**SAFETY EVALUATION REPORT  
REVIEW OF REQUEST FOR PAGE CHANGES TO THE TECHNICAL REPORT,  
SURETY UPDATE, AND THE ADDITION OF TWO VACUUM DRYERS  
LOST CREEK ISR, LLC LOST CREEK PROJECT  
SWEETWATER COUNTY, WYOMING**

**Docket No.:** 40-9068

**License No.:** SUA-1598

**Date:** April 18, 2013

**Figure 11-1. Revised Lost Creek Project Schedule**

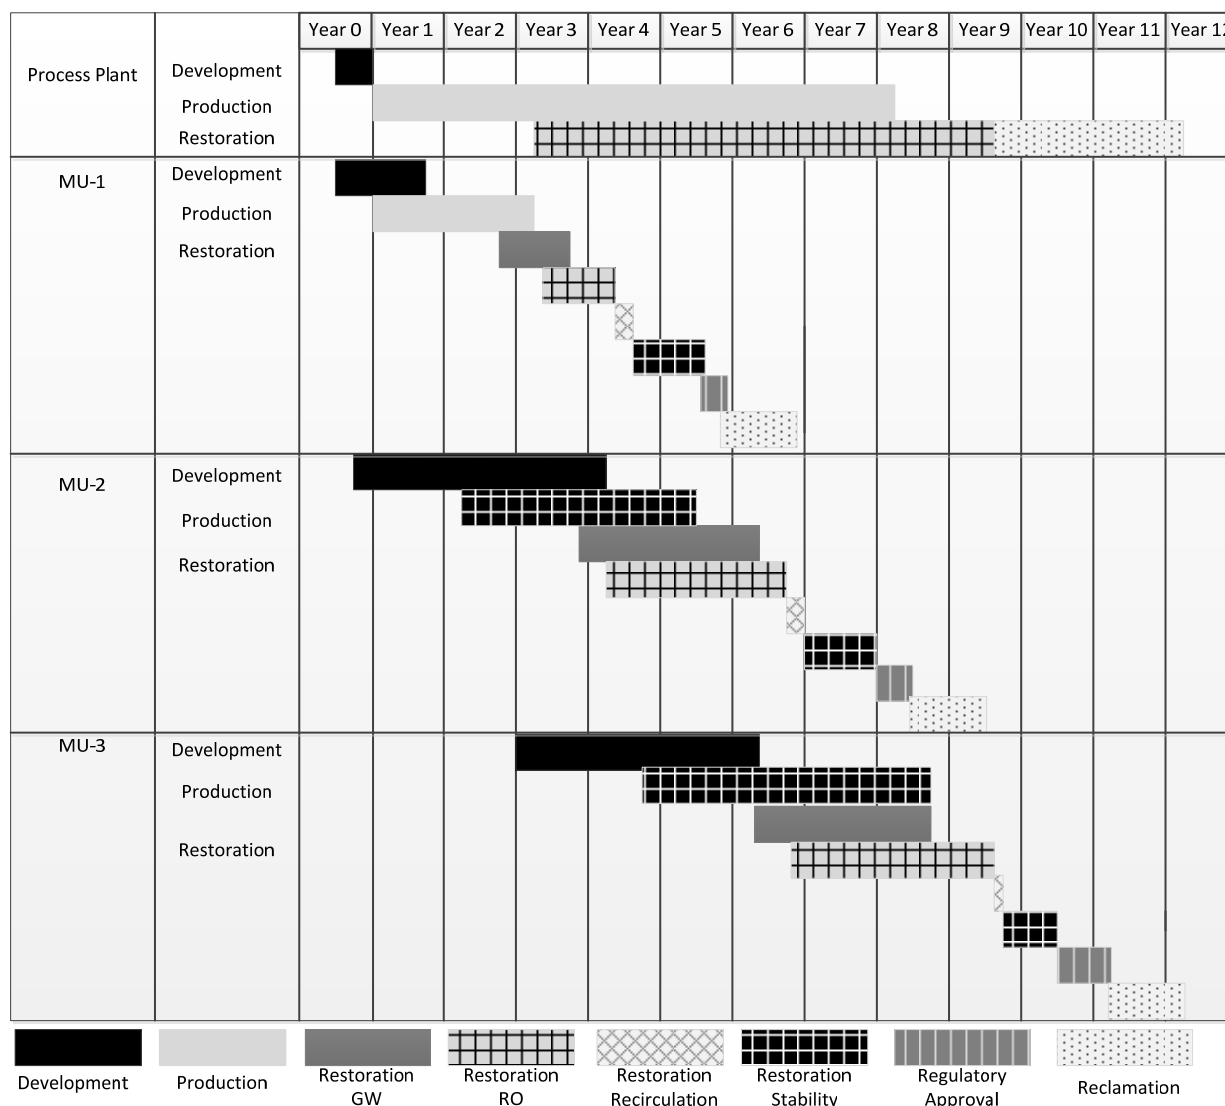
Subsequent to issuance of the NRC Source Material License SUA-1598 (NRC, 2011e), the licensee established a Safety and Environmental Review Panel (SERP) (LCI, 2012a). The SERP has reviewed and approved all facility design changes submitted to the NRC, to include the addition of two rotary vacuum dryers. As described in TR Section 3.1, the original proposed design included three process circuits.

NRC Source Material License SUA-1598 (NRC, 2011e) allows three major processing circuits in the processing plant: ion exchange (IX), elution, and precipitation/filtration. Equipment located in the plant will include IX and elution vessels, precipitation tanks, filter presses, storage tanks, and the associated piping, pumps, and valves required to be able to move the solutions throughout the plant. The licensee's application to amend the license adds a fourth process circuit, the dryer circuit, which will give LCI the option of producing dried yellowcake as a final product in addition to the option of yellowcake slurry production (LCI, 2012a). Allowing both options will enable the licensee to continue production uranium operations regardless of whether or not the vacuum dryers are operational because yellowcake slurry could still be shipped to a licensed facility for processing. The licensee submitted a revised technical report Plate 3.1-1 (also a revised environmental report Plate 2-1) that illustrates the amended processing plant layout.
